AMENDMENT TO  
PUBLIC AGENCY PERMIT

Project Title: Chevron El Segundo Groin and County Outfall Extension

Project Description: Construction of a 900-foot long groin to protect against damaging erosion to Chevron's El Segundo Refinery Marine Terminal. Project includes extension of the Los Angeles County Grand Avenue storm drain.

ATTACHMENTS TO 'MITIGATION'

FIGURE 9

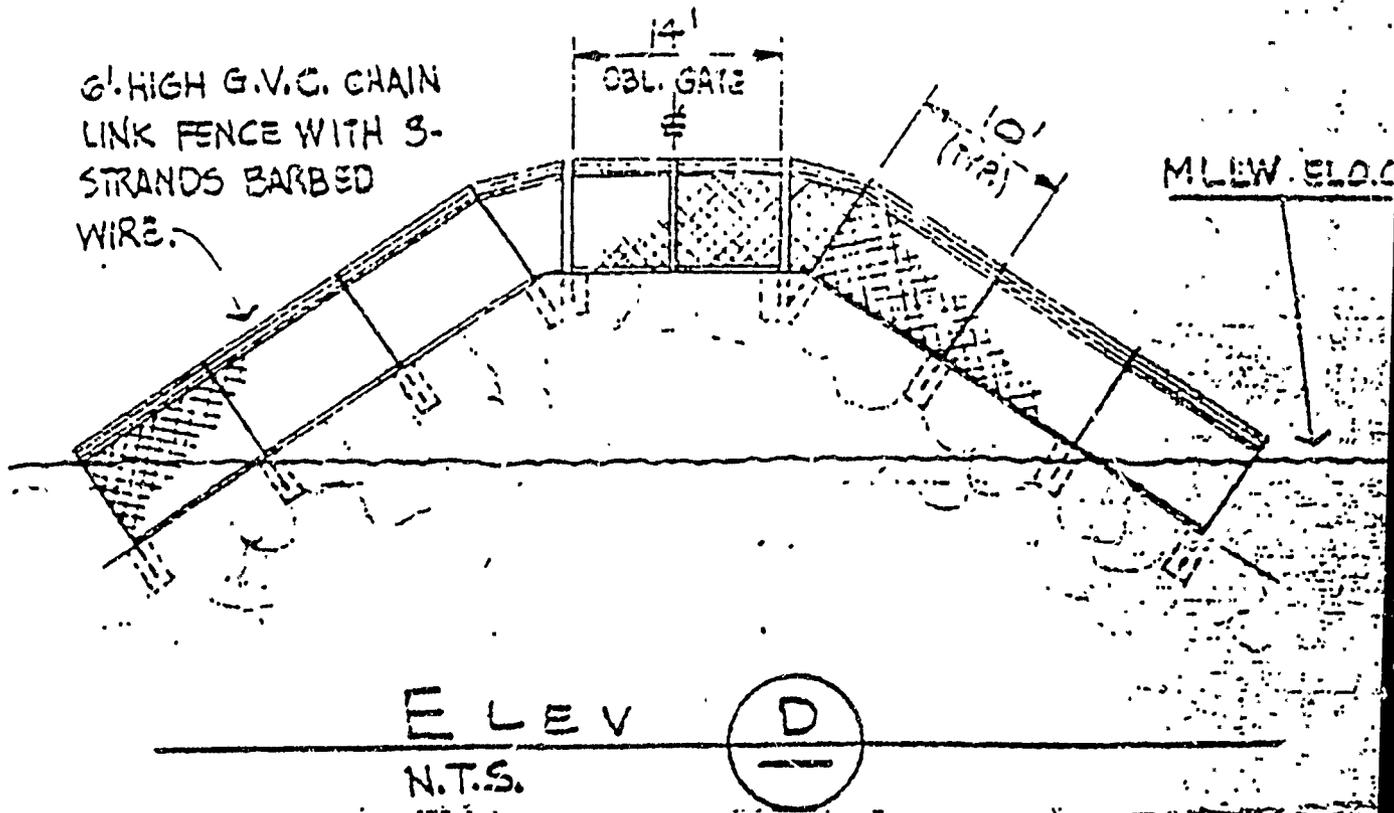
It was pointed out that the groin will constitute an "attractive hazard" if there is access to the structure by the public, and that maintenance and liability responsibilities should be clearly specified. Chevron is constructing a privately-owned structure specifically to protect their own private property being threatened by ocean erosion. As such, it is in Chevron's interest and is their intent to maintain the groin so that it continues to perform its intended function. To minimize the "attractive hazard" aspects of the structure, a 6-foot high chain link fence will be constructed approximately mid-way in the length of the groin to minimize the possibility of access to parts of the groin adjacent to and in contact with the sea. In addition, a guard rail and chain will be located at the shoreward end of the groin to prevent bicyclists from gaining easy access to the top of the groin. These two security structures are shown in attached Figures 9 and 10. Chevron will assume liability for construction and maintenance of the groin, and will provide the County and/or State with documentation relieving them from any such liability.
